AGENDA
PUBLIC WORKS COMMITTEE MEETING
Tuesday, December 18, 2018
6:00 p.m.
City Hall Conference Room
800 Game Farm Road, Yorkville, IL

Title: Storm Water Basin Inspections

Date: December 5, 2018
Subject: Storm Water Management Basin Inspections

DRAINAGE AND GRADING PLAN				
RUSH-COPLEY HEALTHCARE CENTER PHASE 1				
FILE NAME: CDR GRD	CSGN: BY: JK	JOB NO: 903097	PLD: BK/PG: ---	SHEET NO: 32 of 46
DIR: 903067	DRN: BY: DWG	DATE: 03-09-07	SCALE: 1" = 30'

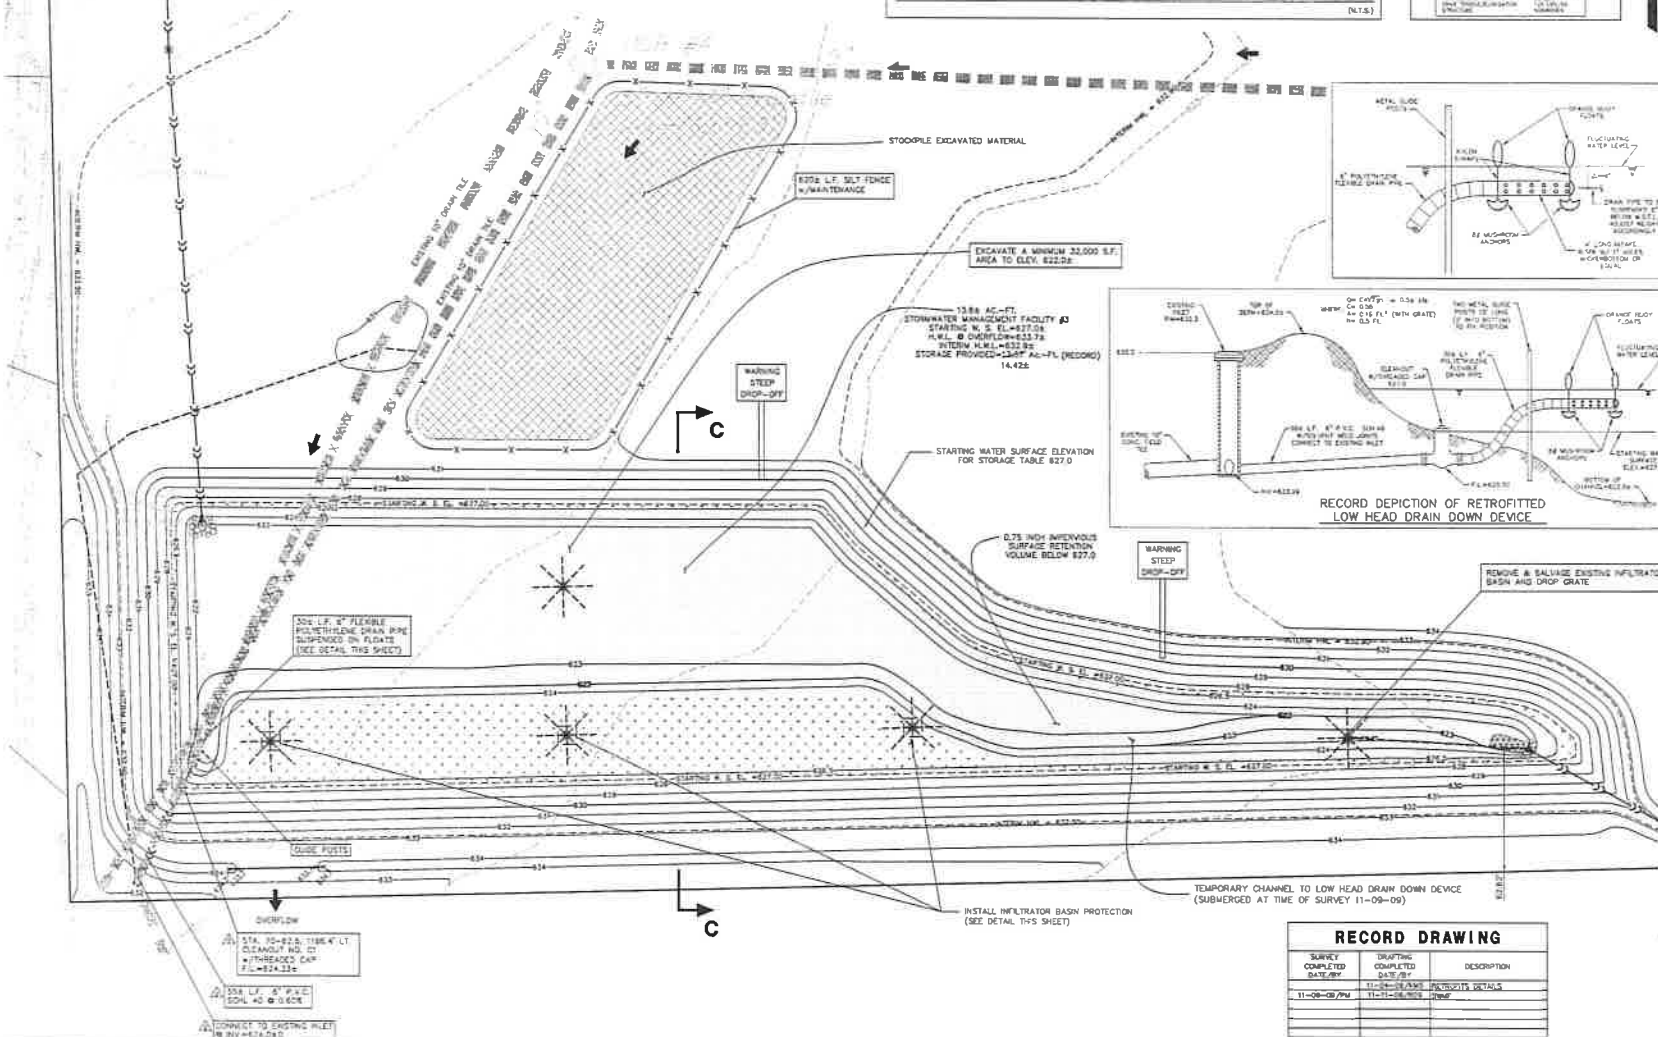
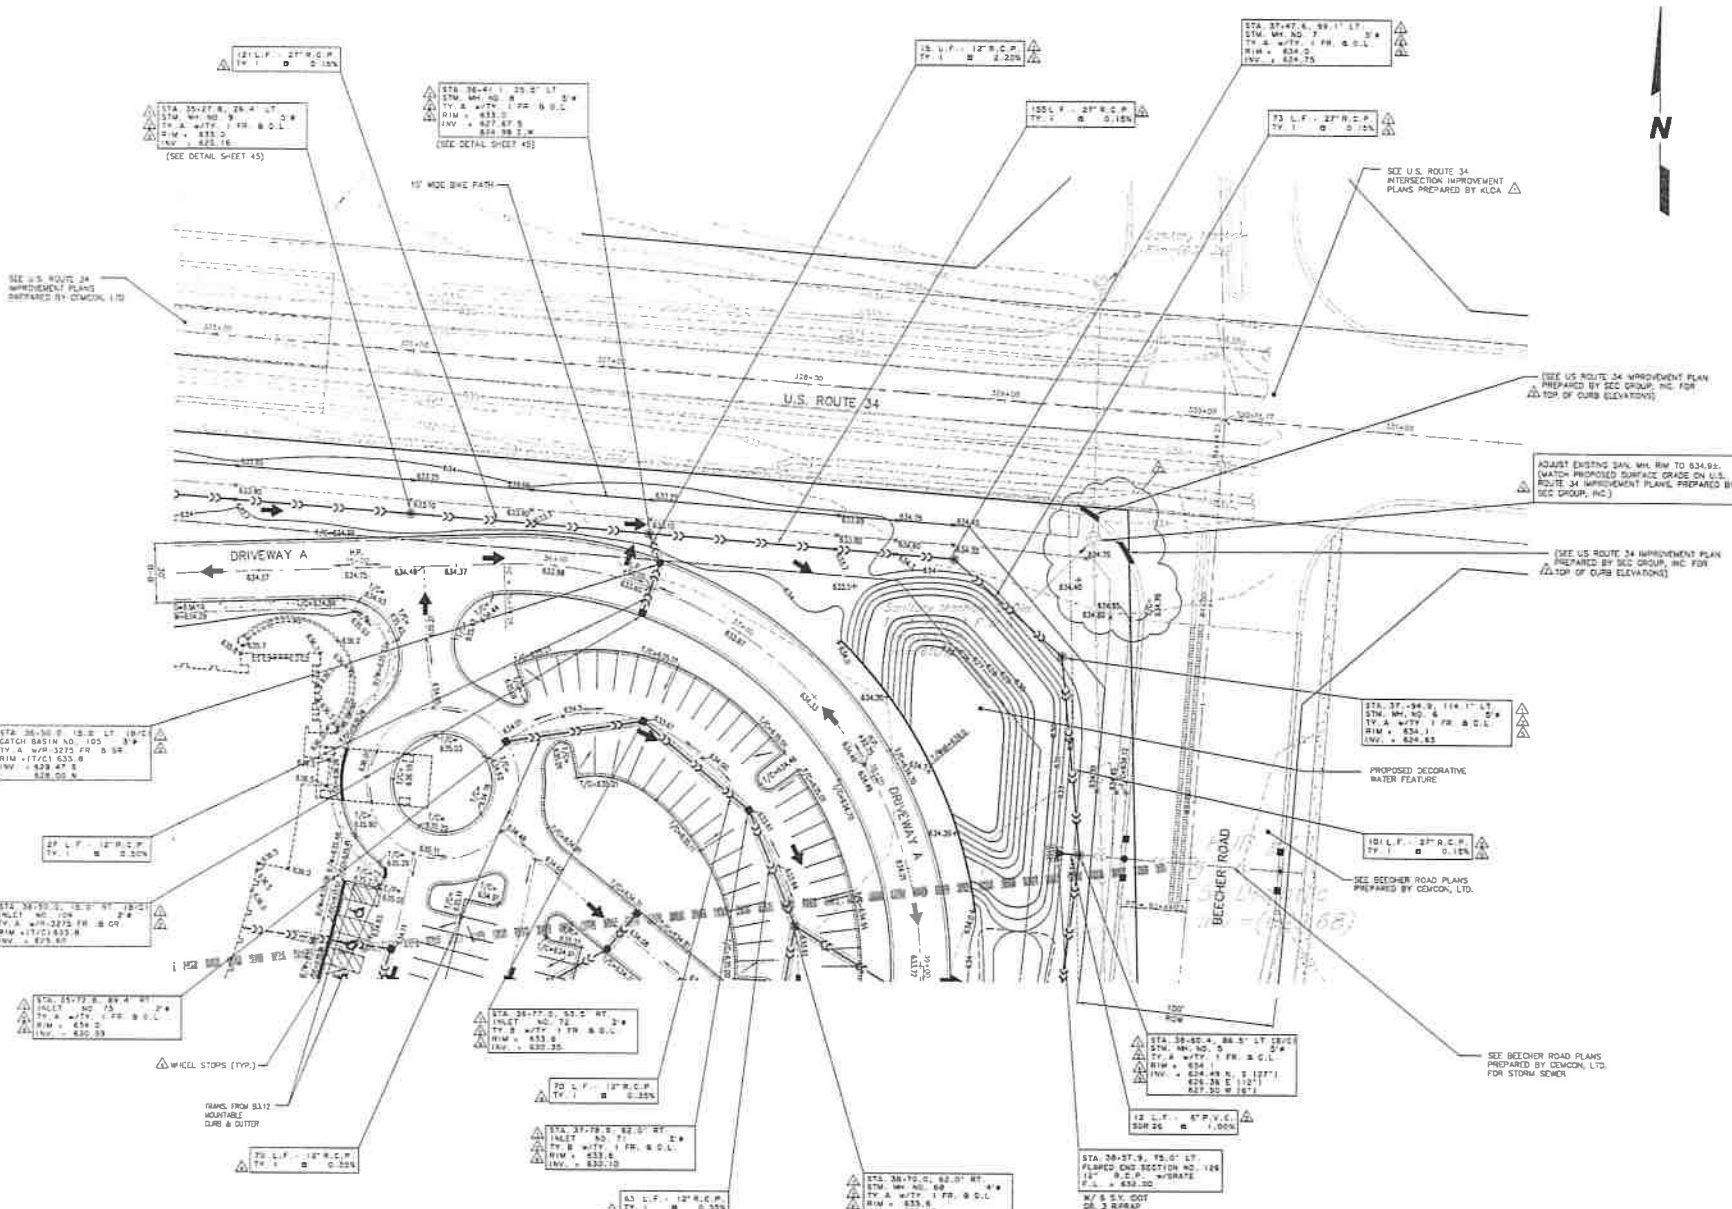
STORMWATER MANAGEMENT FACILITY INSPECTION REPORT**Basin Location:** Rush Copley Healthcare Center**Basin ID:** NW-02-30-206 (Most North Basin)**Parcel Number:** 02-30-200-019**Basin Type (circle):** Dry Detention**Wet Detention****Naturalize****Owner Name:** Copley Ventures Inc.**Owner Contact Number:** _____**Inspection Date:** 05-30-2018**Inspector(s):** JCV

Any Additional Comments/Concerns:

KYLYN'S RIDGE
YORKVILLE, ILLINOIS
DETENTION BASIN No. 1 - DETAILS

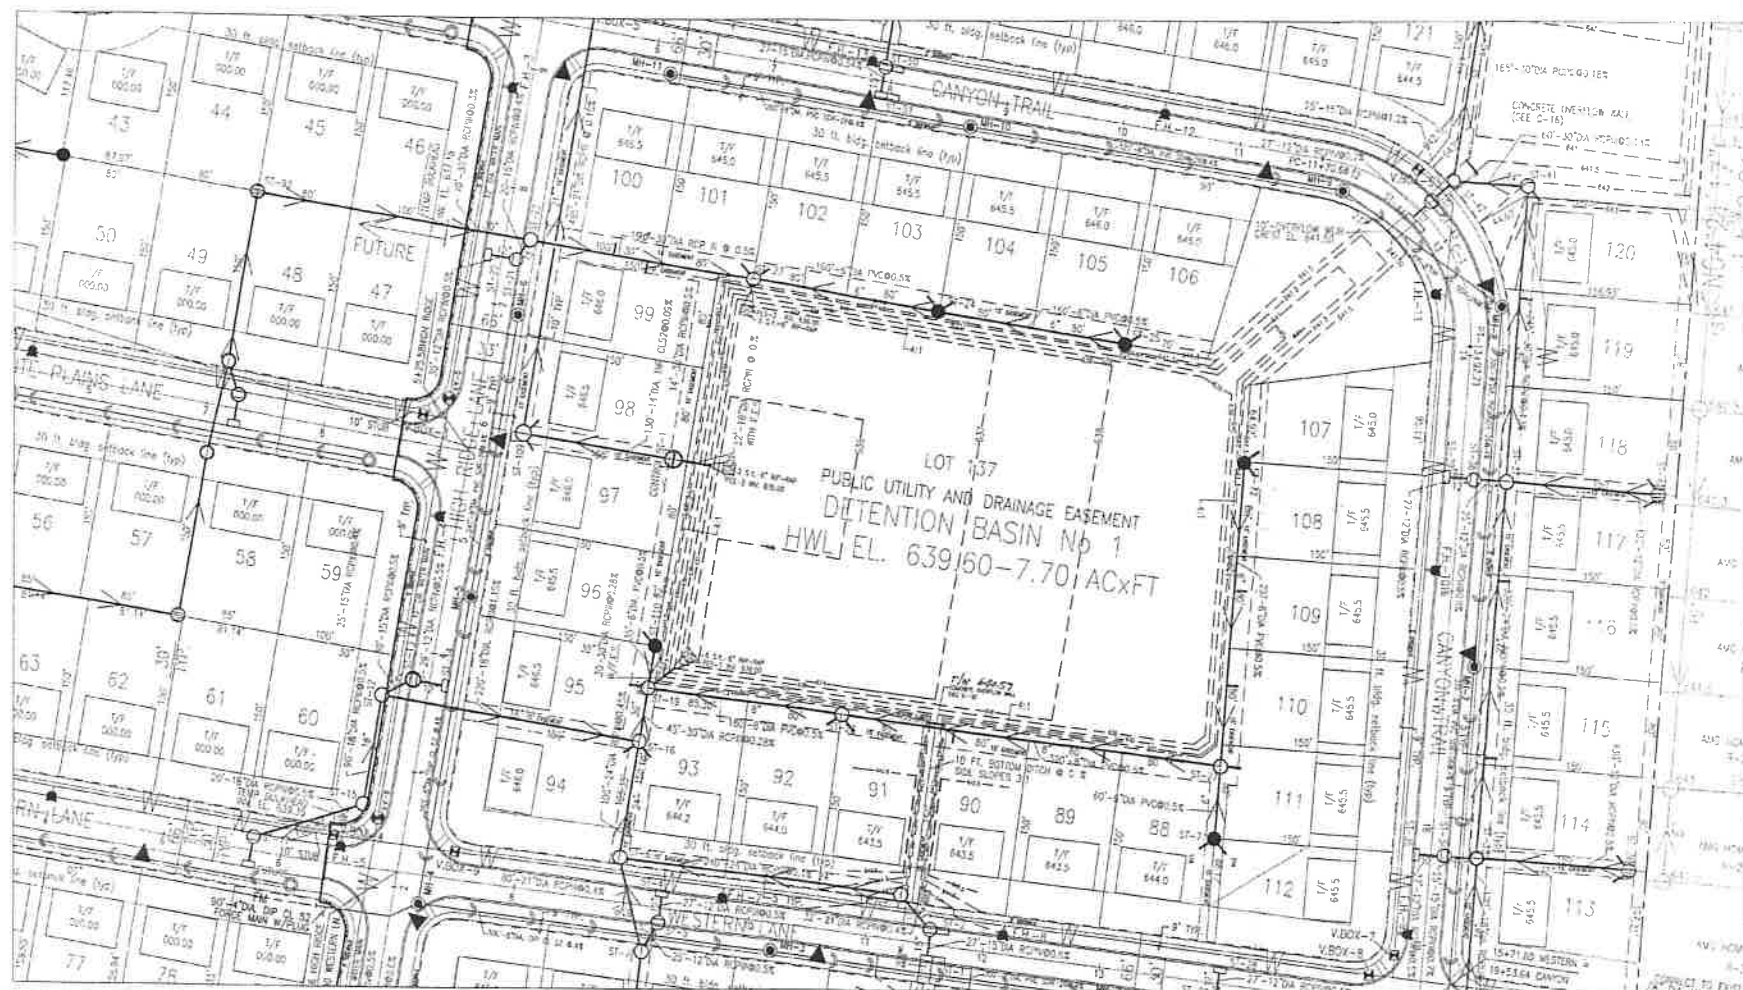
FES-1, FES-3, and FES-4 are heavily overgrown with woody vegetation and weeds.
